Re: Finance Docket No. 34284

Thank you for sending your Notice of Intent to Prepare an Environmental Impact Statement on the above proposed FD 34284. In response, I am submitting the following to be considered in the formal scoping process.

Historical Sites

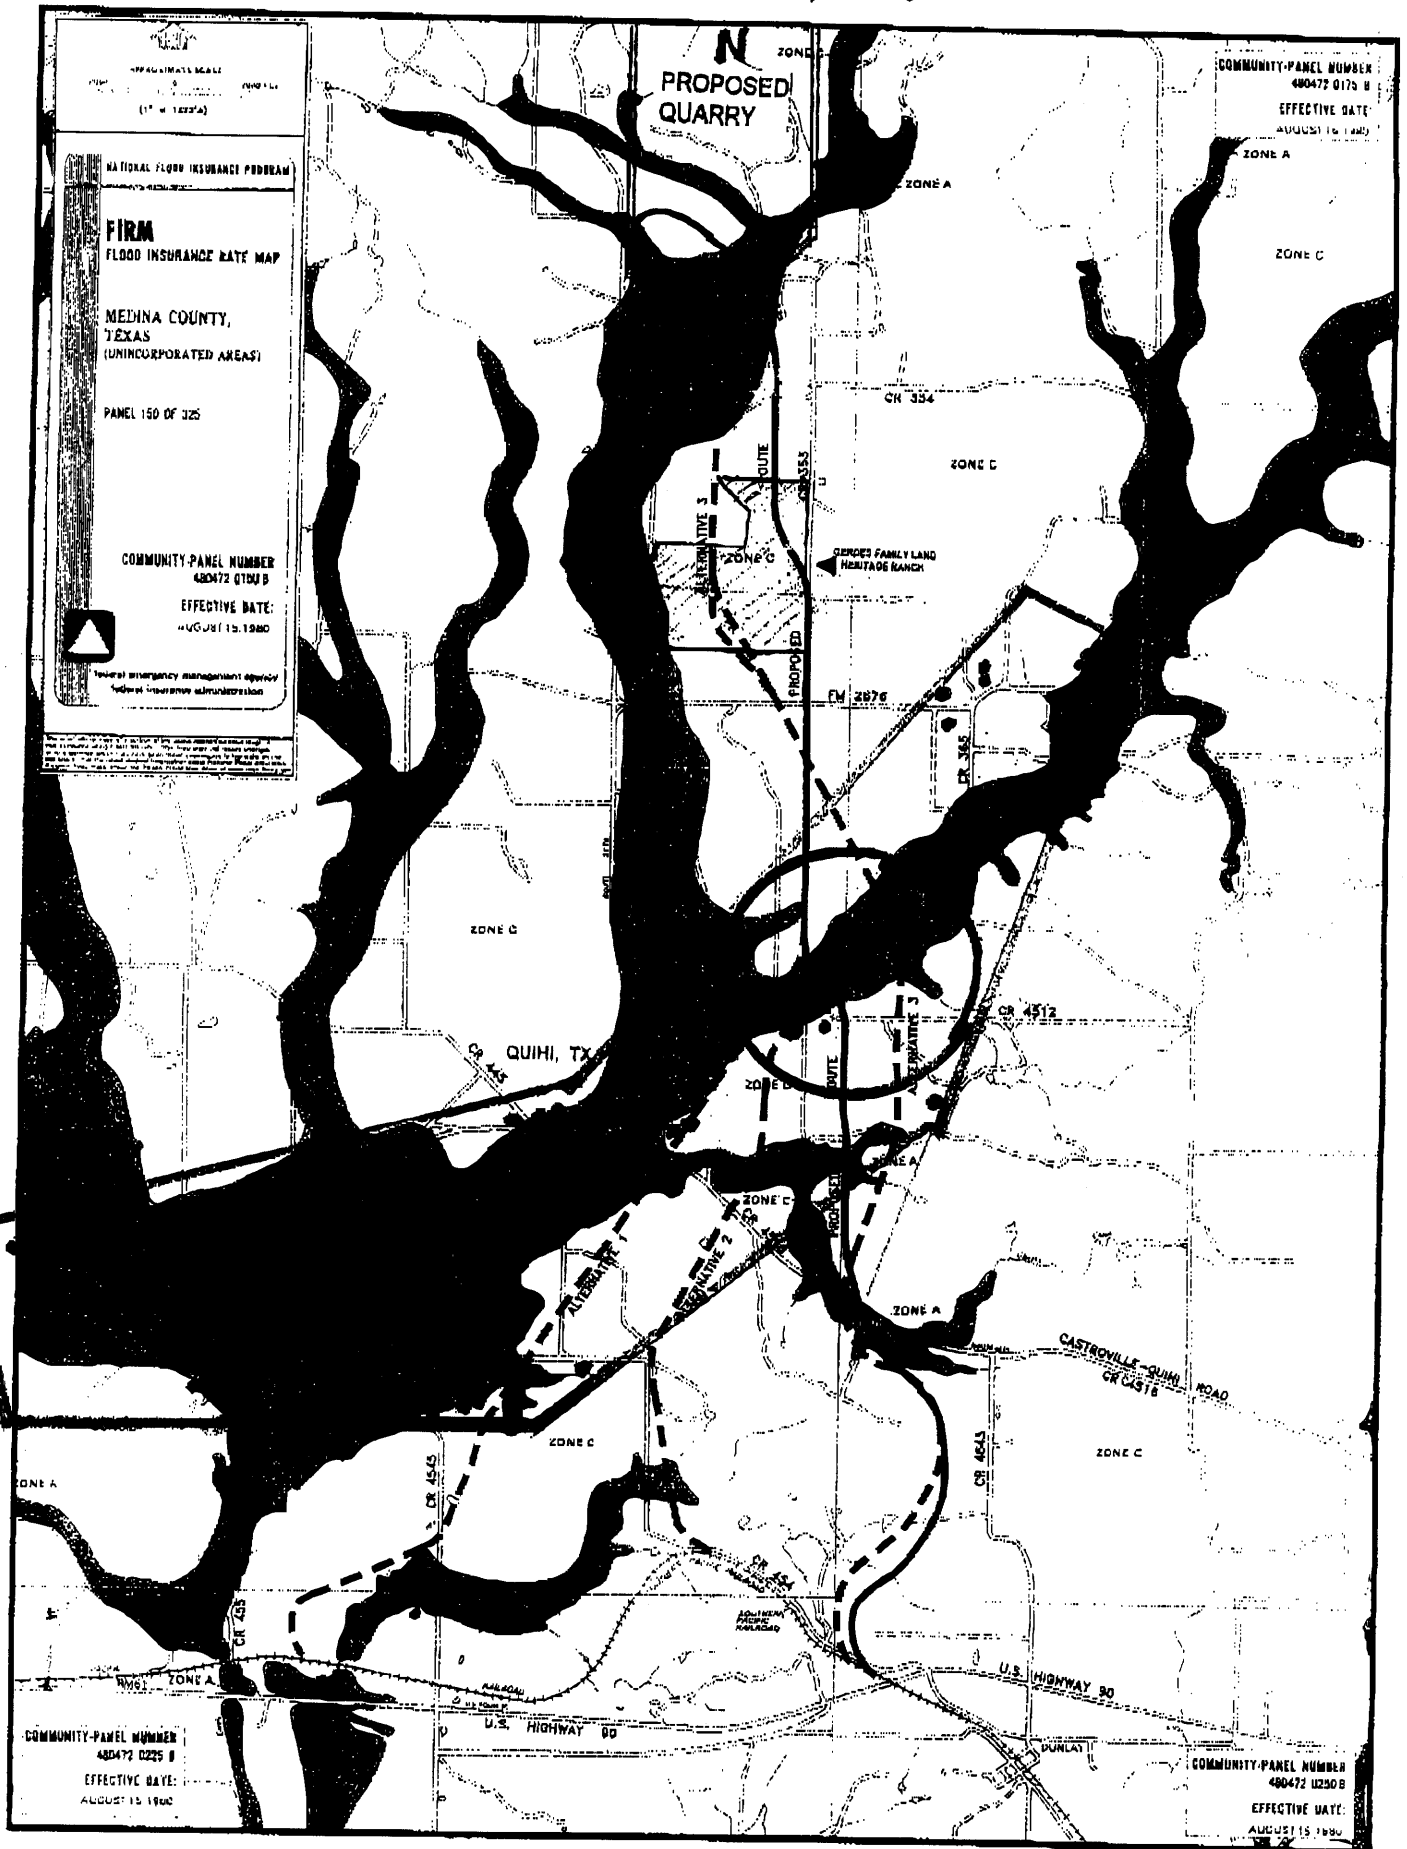
Enclosed is a Historical Sites map outlining the area of the rock Alsatian homes, schools, churches and cemeteries dating back to the mid 1800's. Encircled is the point of the proposed and alternate rail lines crossing CR 365 in this district, through the floodplain. CR 365 was originally known as Upper Quihi Road at the time of the early settlers. This road followed the Quihi creek, connecting the settlers homes to each other. Trains crossing CR 365 would divide this district. The aesthetics would be destroyed by mile-long uncovered gondola train cars loaded with crushed limestone, with their associated noise, dust and vibration, crossing this historic area four times daily. Further, if the crossing were at grade level, the accompanying berms would exacerbate the flooding that occurs *regularly* at this low point in CR 365. If the crossing were elevated, the train would be even more visible. There is nothing charming about 100 dusty gondola cars of crushed limestone. Crossing at this location, whether grade level or elevated, is completely undesirable aesthetically. The EIS should include this in its study.

Another alternative route must be found outside of the Quihi floodplain. Moreover, all issues related to the problems the quarry/railroad presents must be resolved before the project is started. If this is not possible, the quarry/railroad project should be abandoned.
